**STAFF REPORT: 8/9/2023 REGULAR MEETING**

**APPLICATION NUMBER: #23-8484**

**ADDRESS: 2485 BURNS**

**SCOPE: ALTER FRONT PORCH**

Figure 1, by Applicant: proposed front porch

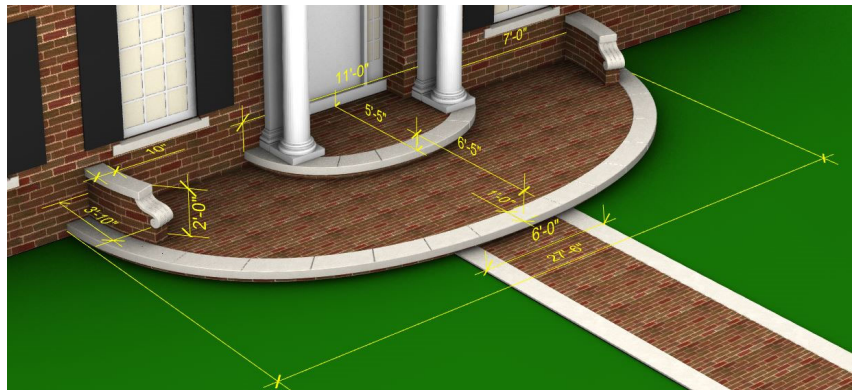
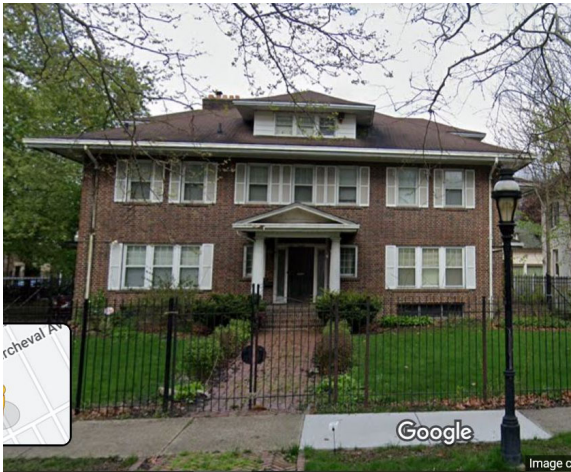
- It is staff’s opinion that the introduction of 4x8 cement pavers, replacement of the square form with circular forms, and the introduction of wingwalls destroys the character defining features of the front elevation critical to an understanding of the building’s style by introducing a new style and historically anachronistic material, scale and design that is not appropriate.

- Staff reviewed the Fendt material as proposed by looking at the companies supply materials and the proposed material in this application. Even though the applicant states that this material is clay-fired brick, staff found that this material is concrete. Concrete pavers are not an appropriate material for replacement of the limestone deck of the porch nor the front porch steps and walkway. Staff recommends that a more appropriate material is clay-fired brick for the expanded first step and walkway only, but not to replace the existing front porch limestone deck.

- Staff does offer the observation that retaining the original material of the porch deck, its rectangular form and scale of the top step supporting the columns, and the potential modest expansion of the first step, maintaining a rectilinear geometry, rather than introducing a circular form, and the elimination of the introduced element of the wingwall could be an appropriate solution that would meet the Standards.

- It is staff's opinion that the proposal to replace the front porch's material from cast stone and limestone to concrete pavers and new limestone does not match the house's material nor scale, changing the shape of the front porch to a circular form, and introducing "wing walls" that diminishes the front elevation the house's Georgian Revival architecture would destroy the original scale, design, and materiality of this historic property, and therefore does not meet the Secretary of the Interior's Standards for Rehabilitation.

- The expansion of the width of the lower step to the extent that is shown, 27' wide, rather than a more modest increase, say one that extends out to the first window, for example, and the expansion of the sidewalk by approximately 2' creates a break from these elements supporting the complexity and scale of the front entrance, by reducing their importance, and call more attention the porch steps and sidewalk themselves. This extensive expansion along with introduction of a curved form alters historic character defining features and is not compatible in scale that characterize this property and therefore does not meet the Standards.

- The proposed replacement of cast stone and limestone stone decking of the porch, by introducing concrete pavers and new limestone in a circular form destroys historic distinctive character defining features of the classically inspired building.
- The introduction of wingwalls adds a new element that obscures and diminishes the distinctive, character-defining features of the Georgian Revival architecture.
- The expansion of the scale of the lower step and sidewalk are at a scale and width that diminishes the proportions of the approach and entrance to the building, thereby breaking the composition and complexity of the façade elements by over-extending the modest foundation that supports these character-defining features of the entrance.
- Concrete pavers are not an appropriate substitute to clay-fired brick pavers in the Indian Village Historic District.

Staff therefore recommends that the Commission issue a Denial for the above work items, as it do not meet the Secretary of the Interior's Standards for Rehabilitation, specifically Standards:
